**SONY** ..... Hi-Fi Products ..  
**Service Bulletin**

**Model:** D-113CR

**No. 364**

**Subject:** defective display (main board cracked)

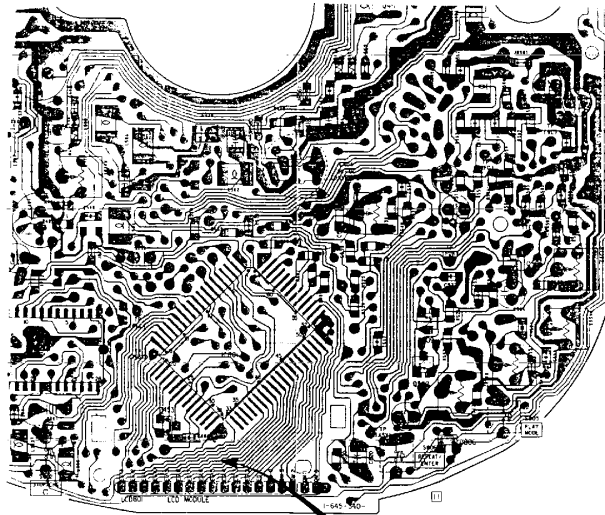
(13) Defective Display caused By A Crack In The Main Board Between IC801 And LCD801.

Add a cushion to the board's area where the crack occurred to prevent it from breaking again.

REF	DESCRIPTION	PART NUMBER
-	CUSHION	3-533-310-11

ADD CUSHION  
IN THIS AREA
